UNITED STATES PATENT AND TRADEMARK OFFICE

APPLICATION NO.	FILING DATE	FIRST NAMED INVENTOR	ATTORNEY DOCKET NO.	CONFIRMATION NO.
10/531,622	04/14/2005	David S. Foell	1200210-2N US	8430
35227 7590 11/13/2008 POLYONE CORPORATION 33587 WALKER ROAD AVON LAKE, OH 44012				
EXAMINER				
SAFAVI, MICHAEL				
ART UNIT		PAPER NUMBER		
3637				
MAIL DATE		DELIVERY MODE		
11/13/2008		PAPER

Office Action Summary

Attachment: Fig. 16 of Johnson '262

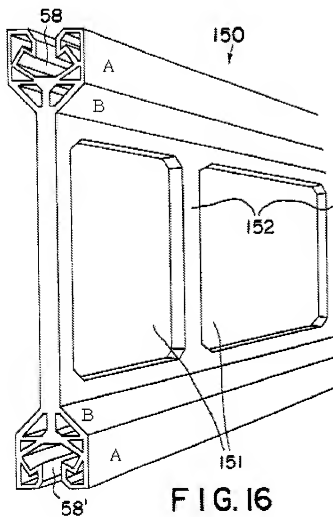
Claims 1, 4, 6, and 8 are rejected under 35 U.S.C. 102(b) as being anticipated by Johnson '262. Johnson discloses, Fig. 16, (see also attached annotated Fig. 16 below), an insert panel 150, wherein the insert panel has one substantially straight or flat surface and wherein the male engagement portions (surrounding 58, 58') at each end extend from a same side of the wall panel, (those engagement portions that surround 58, 58' on the same side of the panel), wherein each male engagement portion has a first projection (A) and an integral second projection (B), wherein the first projections at the ends extend substantially parallel to the wall panel and each other, and wherein the second projections at the ends extend substantially perpendicular to each other.
